Rotax engine type 914 F series, check / replacement of the wastegate servo cable

Check / replacement of the turbocharger wastegate servo cable (part no. 897.940).

All versions of engine **type 914 F series from S/N 4,420.002 up to and including S/N 4,420.127.**

Bild / Fig. 2

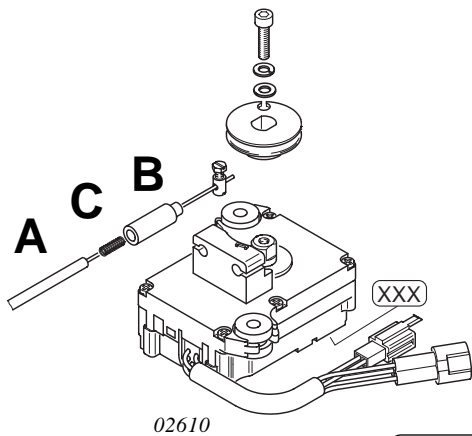
Ensure that the pressure spring in the spring socket is in the right position. See Fig. 2.

Fit the new cable retainer into support on servo motor using a suitable tool, and secure with LOCTITE 648. The new servo cable and the new cable retainer for the wastegate control must be installed and readjusted in conjunction with the servo motor and servo cable as per the current Maintenance Manual 914 F, chapter 13.5.4.3). Wire secure servo motor to crimp band clamp of servo cable.

Bild / Fig. 1

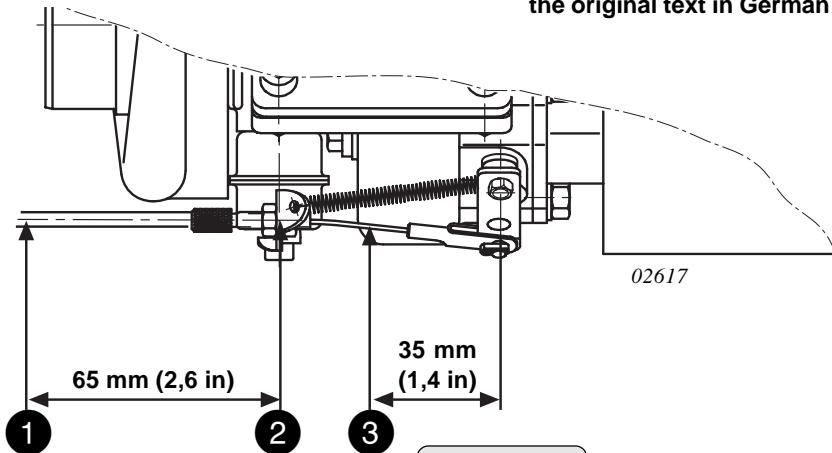
Following temperatures must be measured on the positions set out in figure 1 and must **not** be exceeded during take off and after engine stop (heat accumulation).

pos.	description	temperature
①	cable conduit	max. 120 °C (250 °F)
②	cable support	max. 120 °C (250 °F)
③	wire rope	max. 140 °C (280 °F)

◆ **NOTE:** All temperature limits must be verified at the first time of installation of the ROTAX 914 into an air frame, or at any modification of the airframe as it may influence such temperatures.
